Central Subpopulation of Northern Anchovy

STAR Panel Meeting Report

Online
December 7-10, 2021

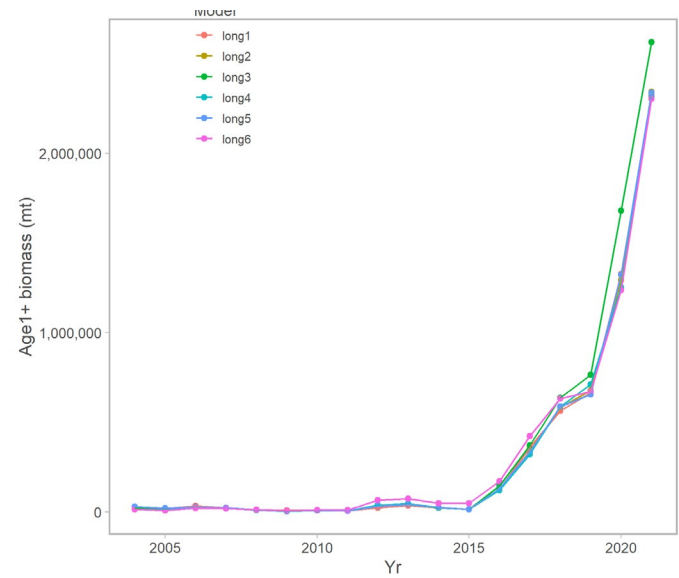
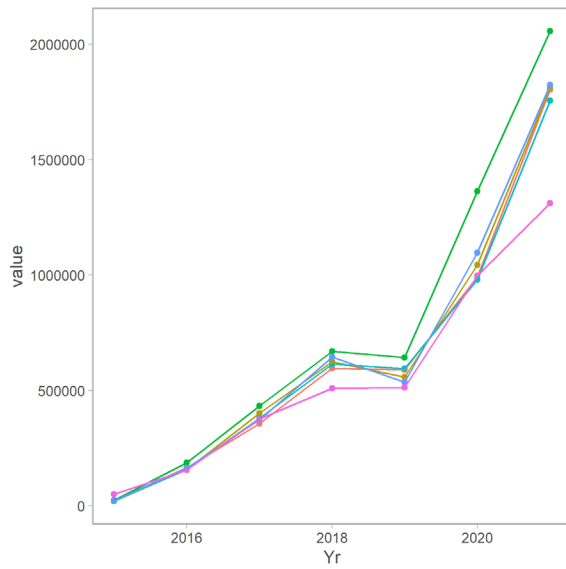
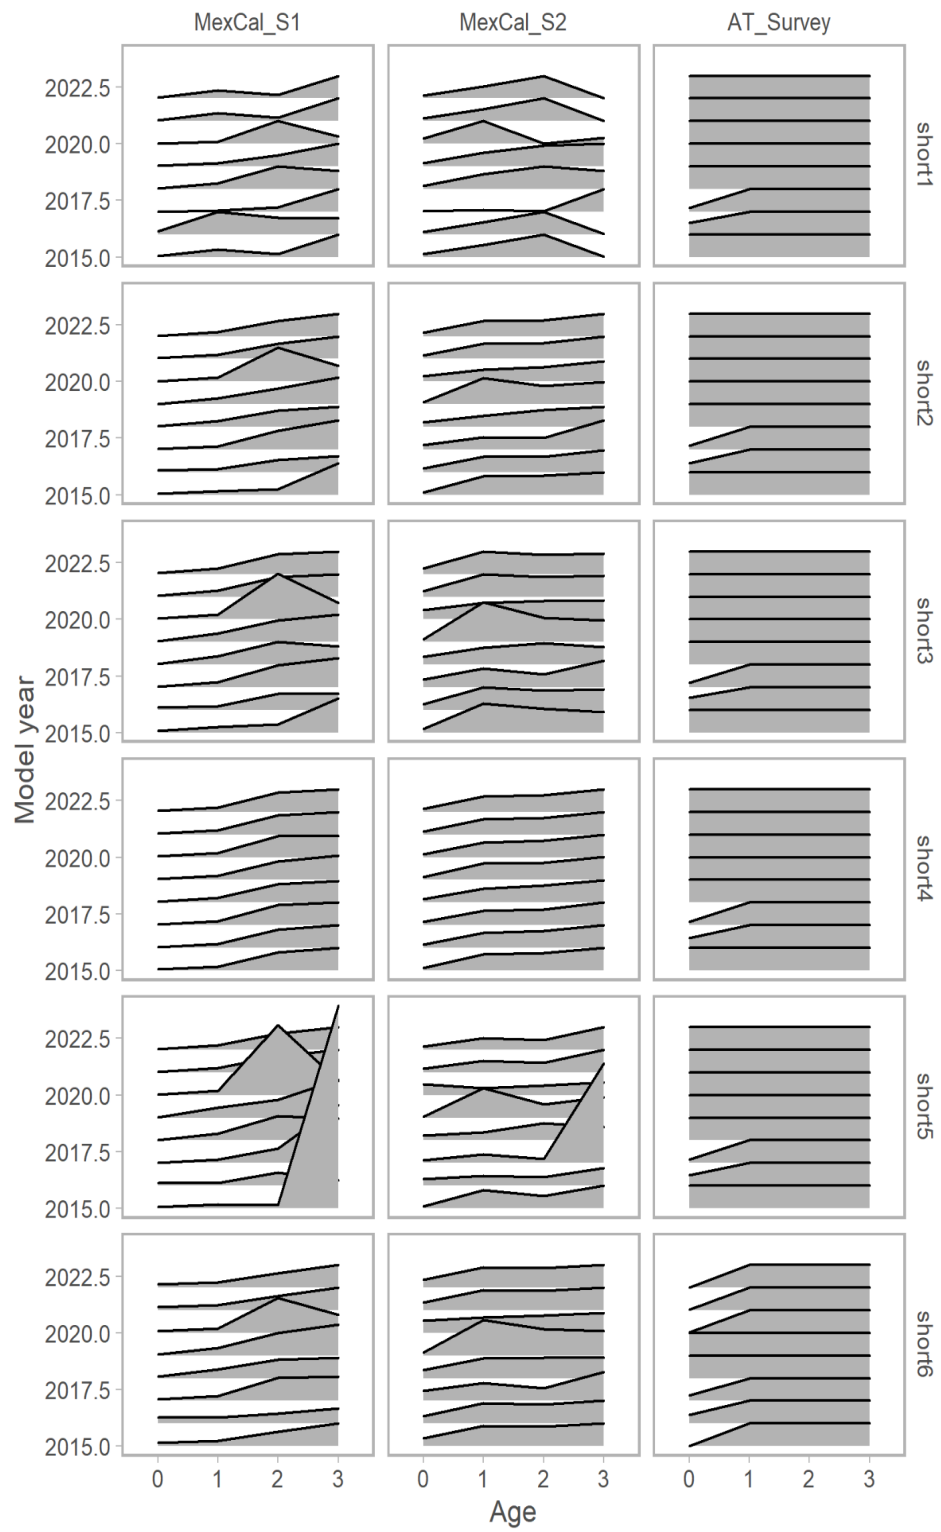
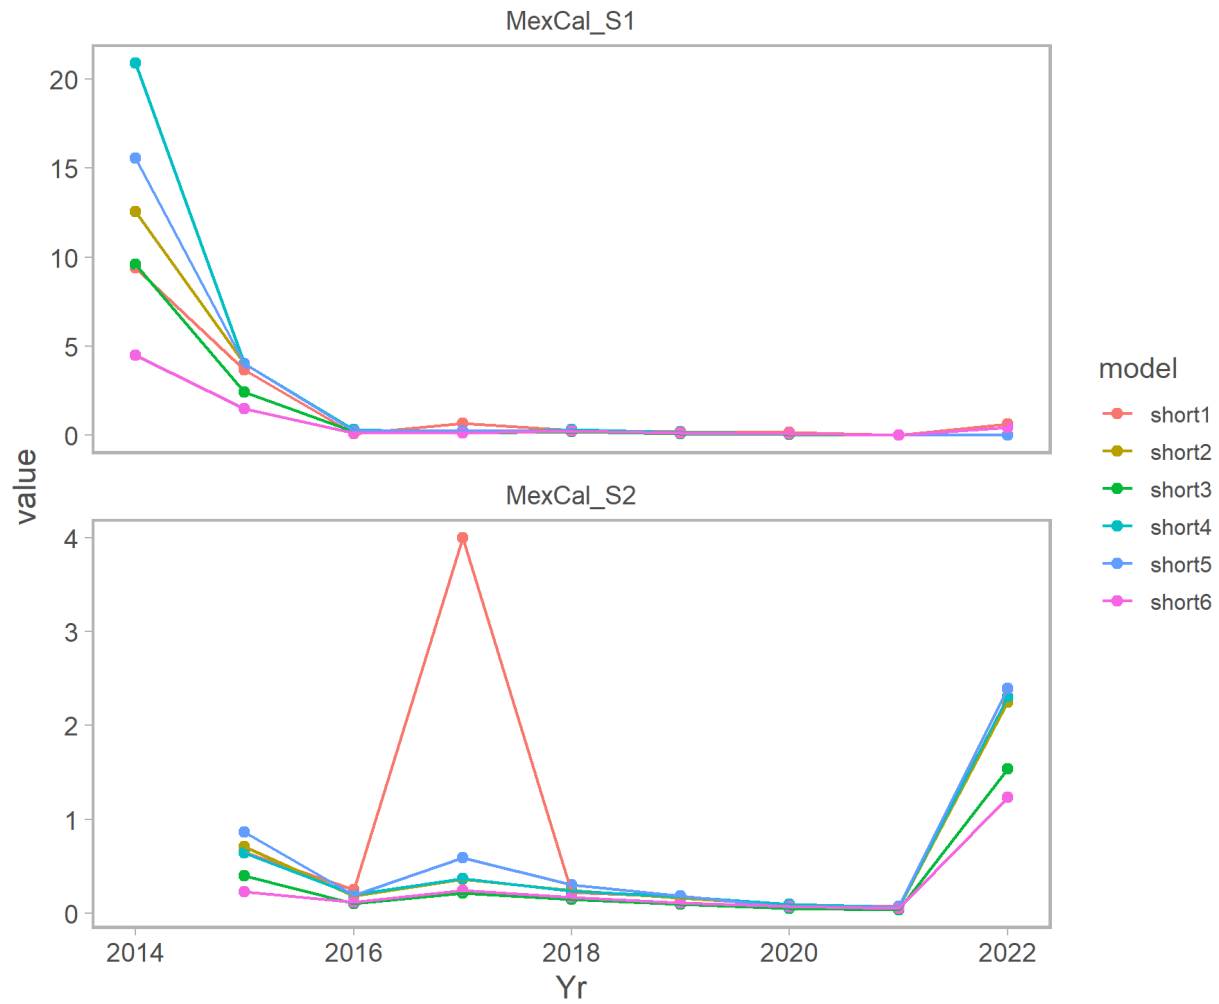
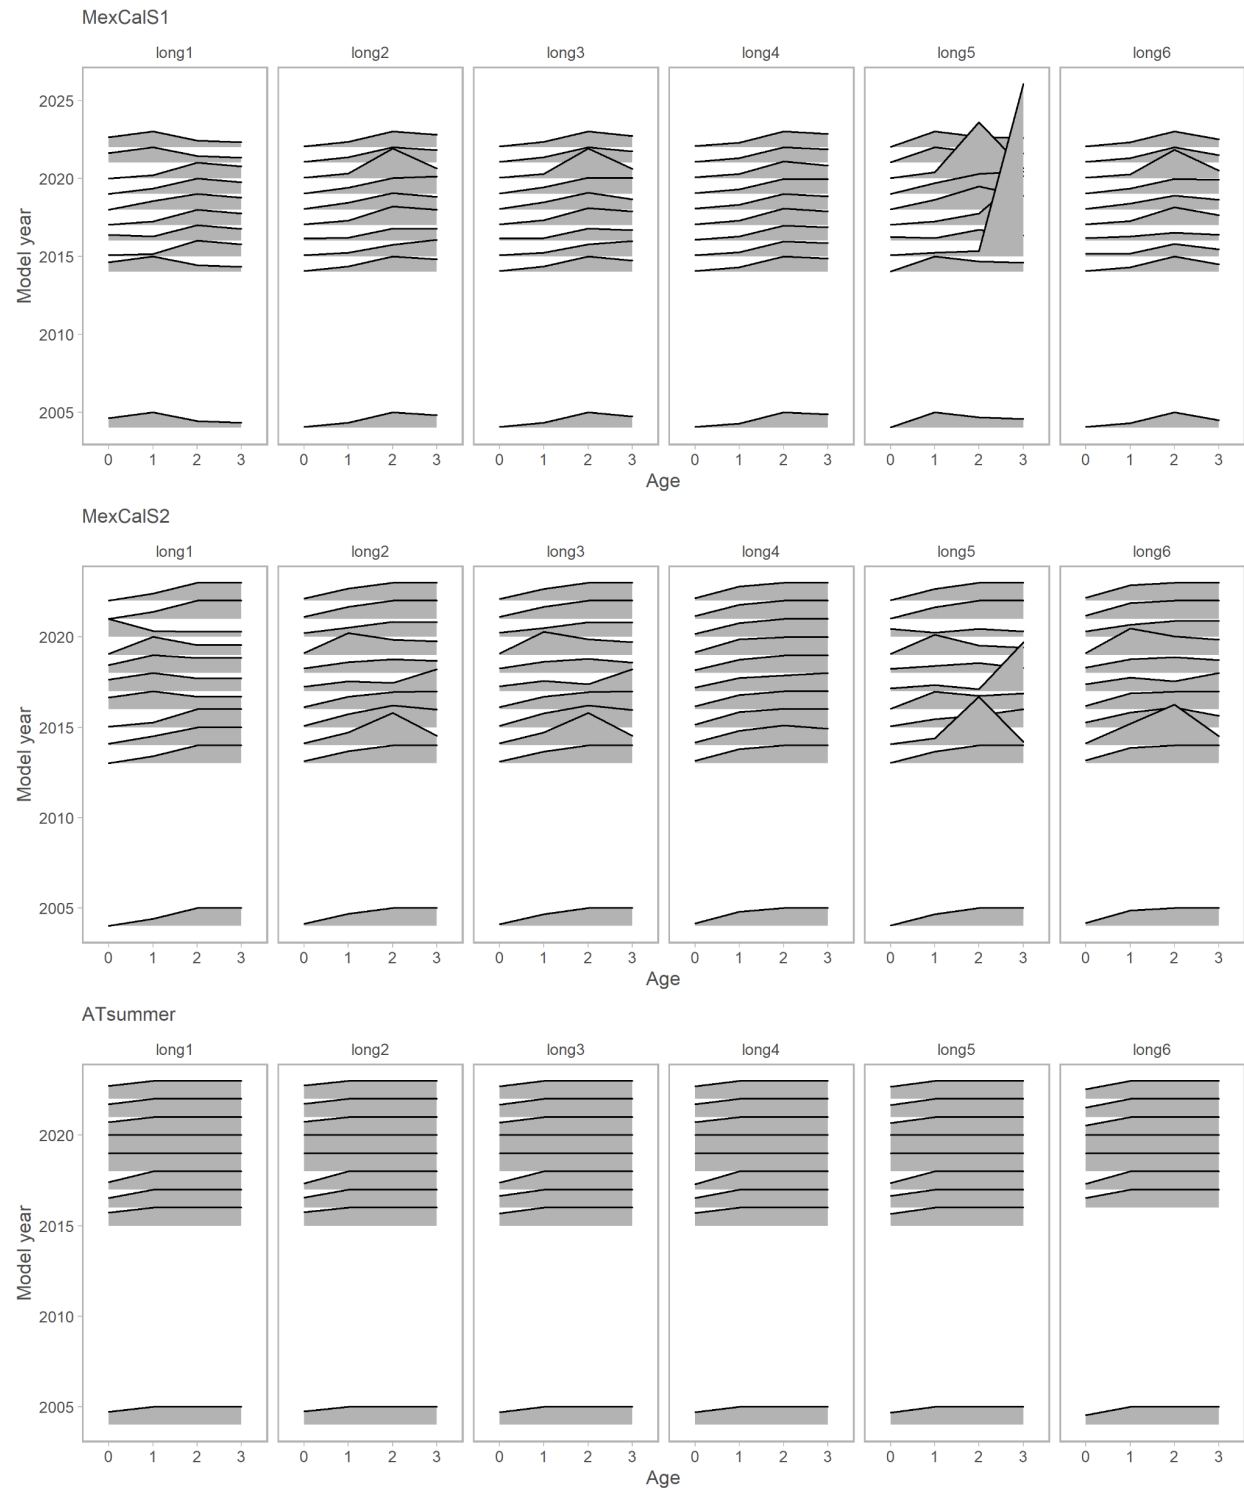
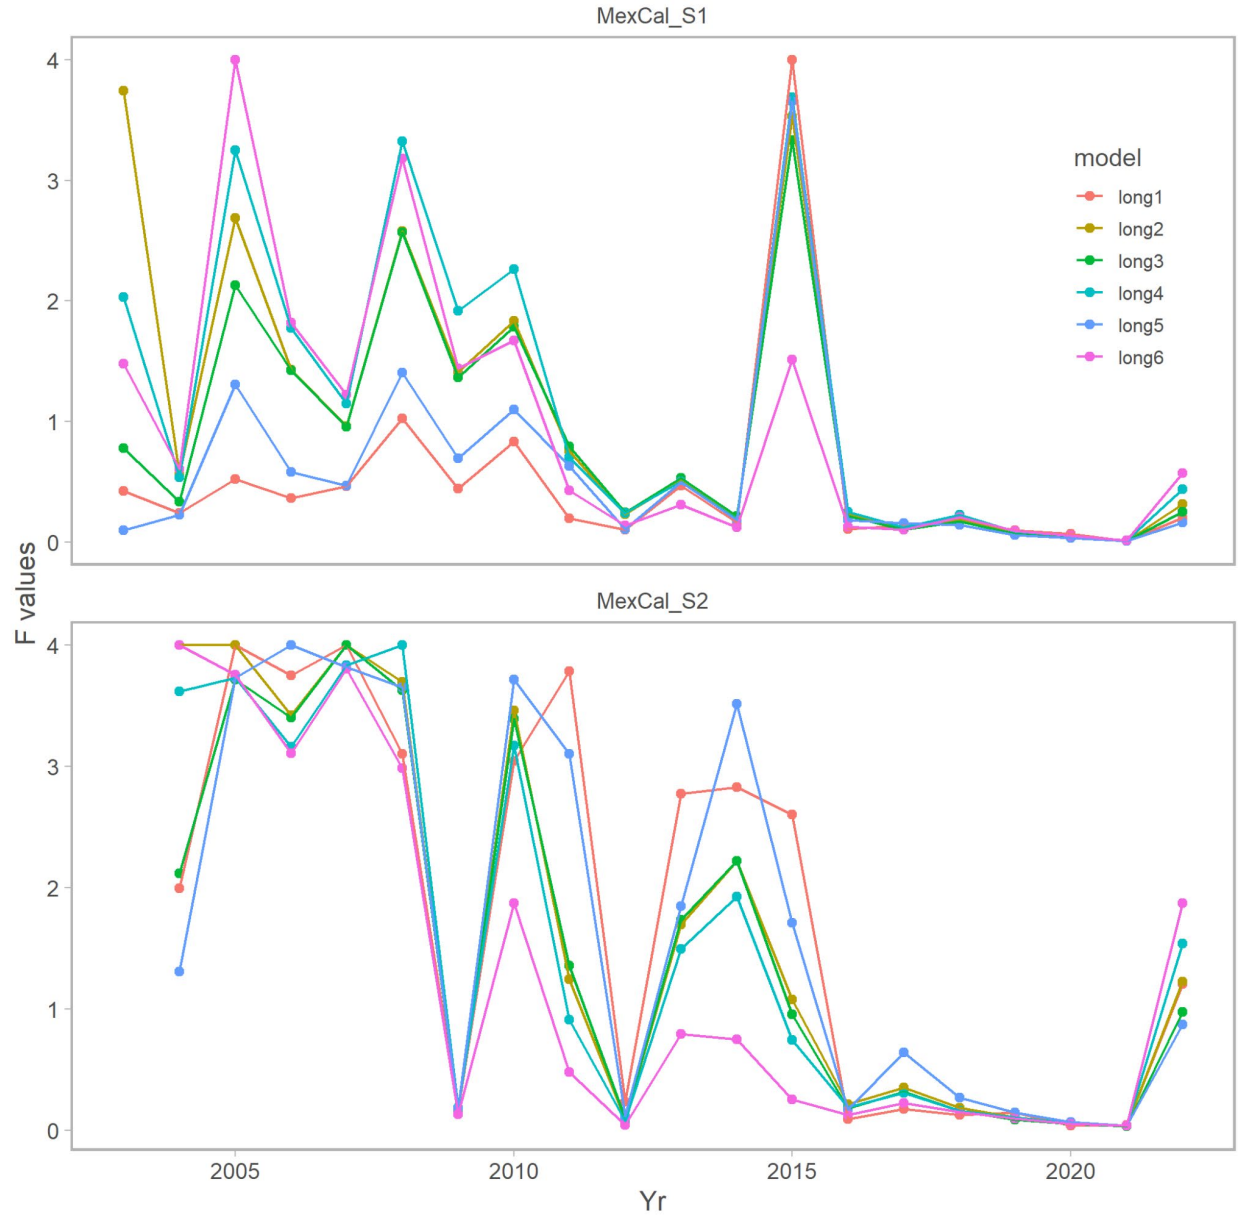
Request 30: Run a set of models as described below, implementing the “agreed changes” listed below in all runs. For each row/model number, both a short and a long variant are requested. Model length “S” means a model starting in 2015 and using the AT survey but not the RREAS. Model length “L” means a model starting in 2004 and using both the AT survey and the RREAS.

Rationale: The “agreed changes” are those for which there is consensus among the Panel and STAT that they are improvements relative to the initial base model, based on the responses to requests so far. Model 1 (short version) reflects the base model in the draft assessment report incorporating these changes. Model 2 (short version) reflects a potential alternative starting point for further exploration that incorporates a change to selectivities that was broadly agreed to maintain or improve fits to data relative to the base model, while appealing on grounds of parsimony and theoretical support. Models 3 through 6 each represent a single axis of change away from model 2 to explore the effects independently. Each model formulation is then repeated across short formulations without the RREAS and long formulations including the RREAS, to explore effects of including the RREAS and analyzing a longer time period.

Response: A detailed response to this request follows over the next several pages. In summary, the STAT and Panel agreed that for the “short” model formulations, model 1 could be ruled out from further consideration because the 2dAR selectivity models performed in ways that were superior (equal or better fit and plausibility of parameter estimates) to the Option 17 selectivity and was better supported on grounds of theory and parsimony, model 4 could be ruled out due to a poor fit to the age data, and model 5 could be ruled out due to poor likelihood and convergence issues. The STAT and Panel further agreed that for the “long” model formulations, models 1, 4, and 5 could be ruled out for the same reasons and also because the model 5 Hessian was not positive definite. Further discussion also led to proposal of a tentative new base model, to be further analysed as described in Request 31.

With steepness fixed at 0.6, it is difficult to decide which parameters to estimate. Looking at the likelihoods would support estimating initF and the R_0 offset or estimating the R_0 offset and not initF . However, these models with low likelihood also have M estimates that do not line up with previous studies.

The negative log-likelihoods (NLLs) should not be compared between the long and short models because they differ substantially in the amount of data included, and NLLs should not be compared directly between model 6 and the other models without considering that model 6 is fit to fewer

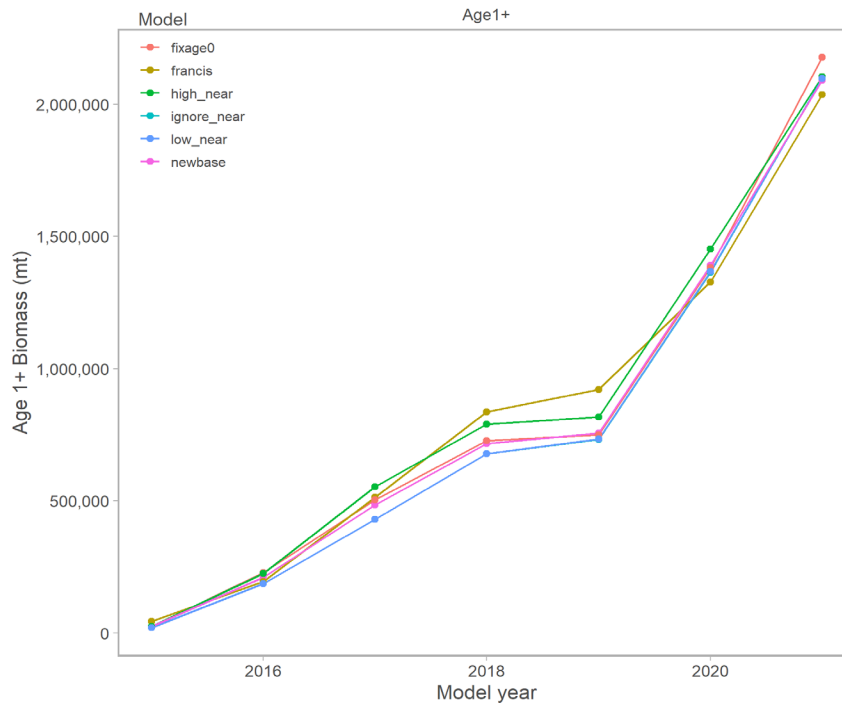
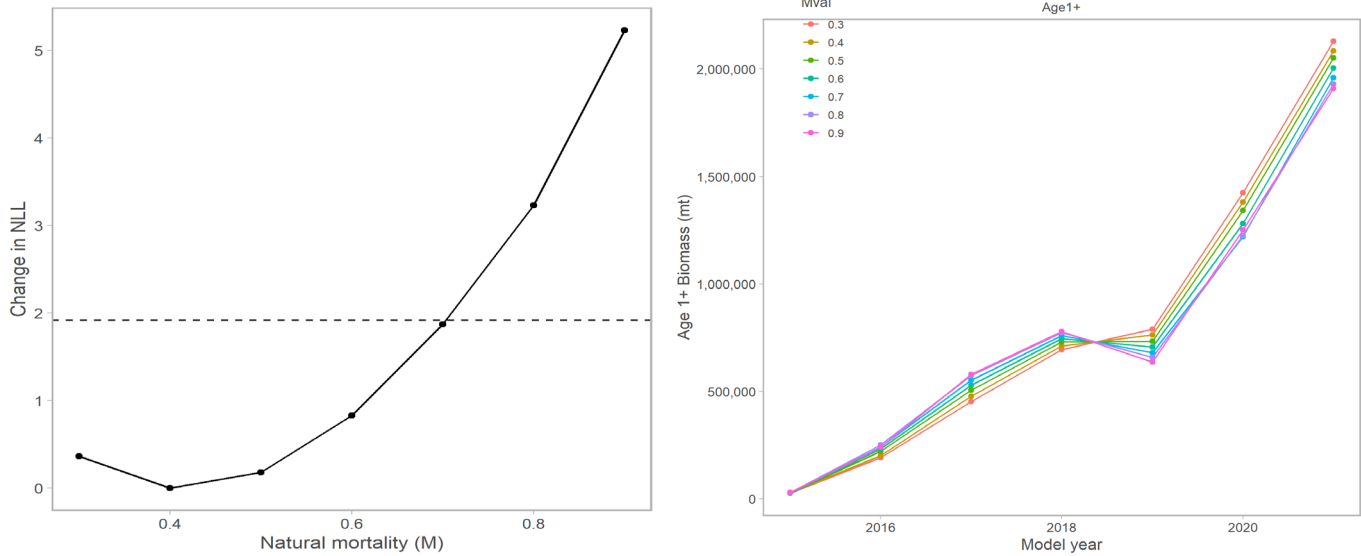
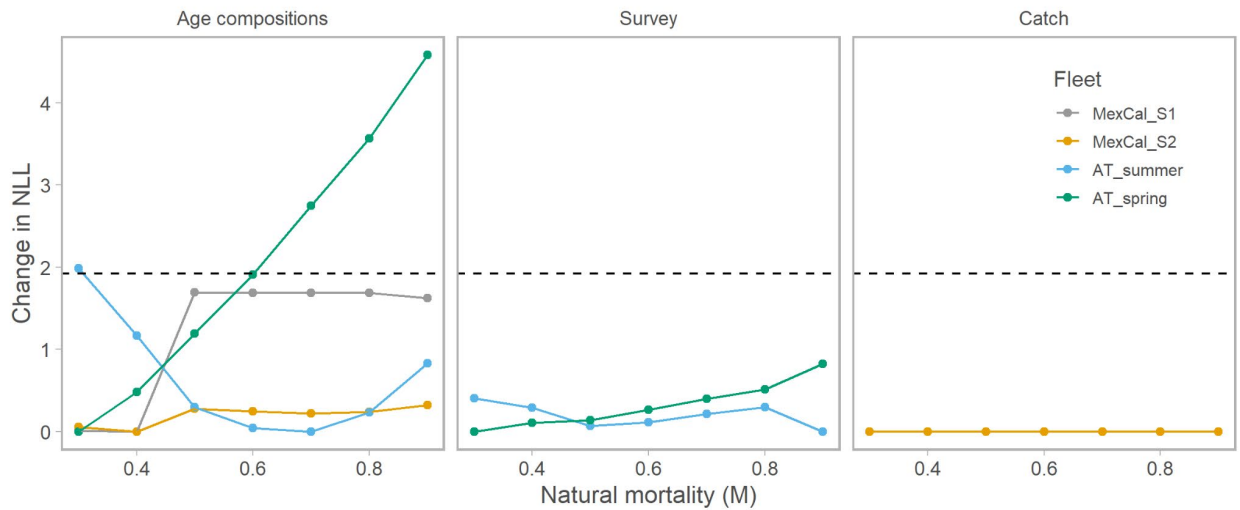
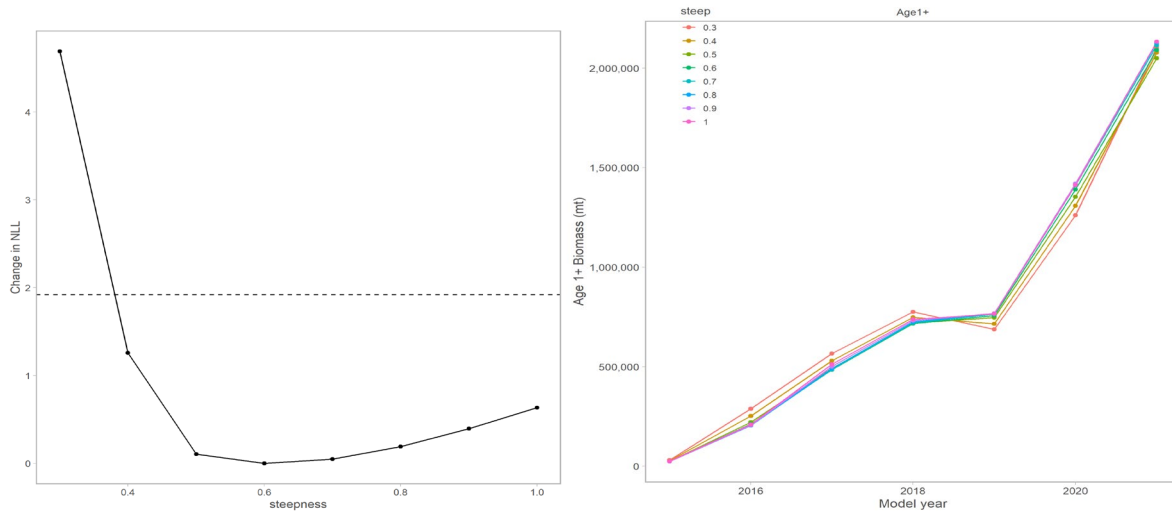
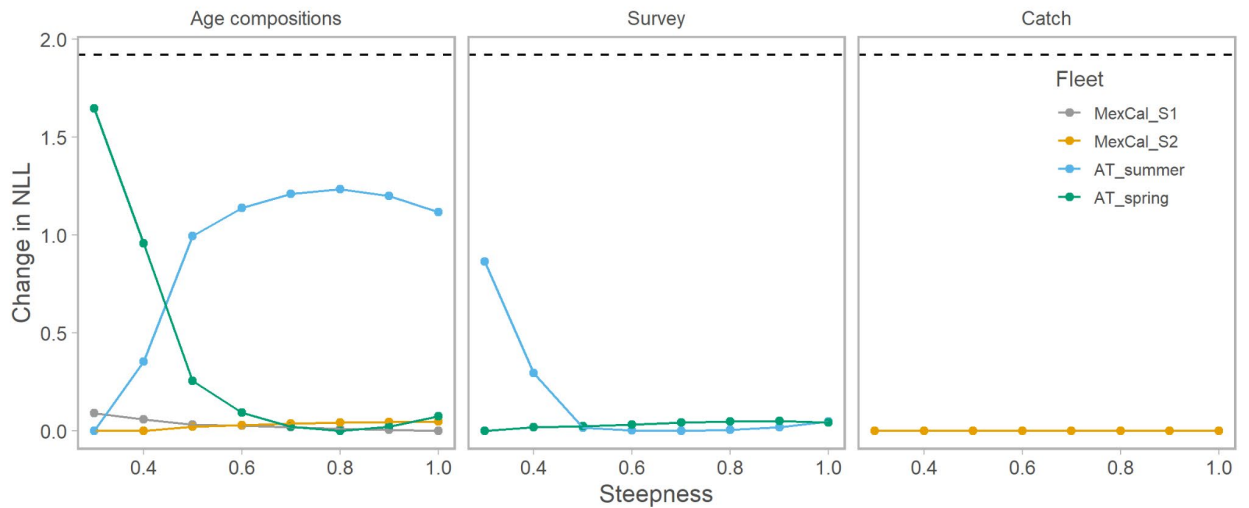
Request 31: Propose and run a tentative base model (structure as described in the Response below) and report:

- Additional sensitivity analyses were requested to show the effects of not including inshore biomass estimates, a run in which the highest possible (out of aerial surveys, small vessel surveys, or extrapolations) inshore estimates were used for each survey, the lowest possible inshore adjustments were used for each survey, exploring the effects of Francis weighting for all fleets at once, and fixing age-0 selectivity for the 2015 AT survey at 0.5.

The figure above shows the age-1+ biomass trajectories for the model period of 2015-2021. The models shown are the base model (“newbase”; pink), a model that ignores nearshore biomass estimates (“ignore_near”; light blue), a model with Francis reweighted age composition for all fleets (“francis”; yellow), a model that assumed the highest nearshore biomass values (“high_near”; green) and a model that assumed the lowest nearshore biomass values (“low_near”; purple).

M profile (age-1+ biomass trajectories) with steepness fixed at steep 0.6 (left) and the biomass trajectories for the alternative values of *M* (right).

Likelihood profiles for *M* by component. Note the conflicting profiles for *M* for the spring vs summer AT surveys. Not many sources favour high *M* from a likelihood perspective and the profiles for the indices are quite flat.

There is little information on steepness beyond ruling out very low values. As steepness goes up, M goes down; but M is less than or equal to 0.65 yr^{-1} over the range explored
